Illustrated Parts List - IPL Update

H560XP/XPG

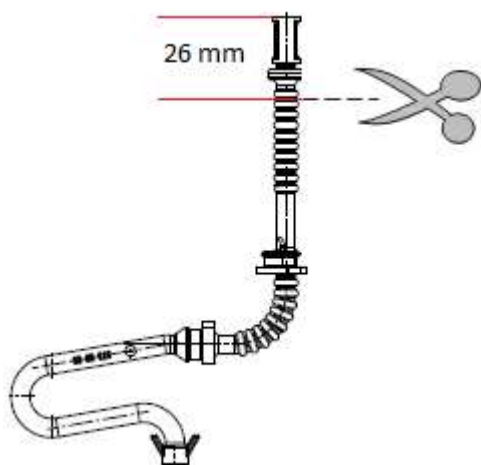
1. New Carburetor, kit 501 46 33-03 added. New angle on fuel nipple.
2. New Fuel hose 577 50 41-01 is 26 mm shorter than old 573 99 35-03 to fit new connection on Carburetor.
3. Choke control changed to secure correct assembly.
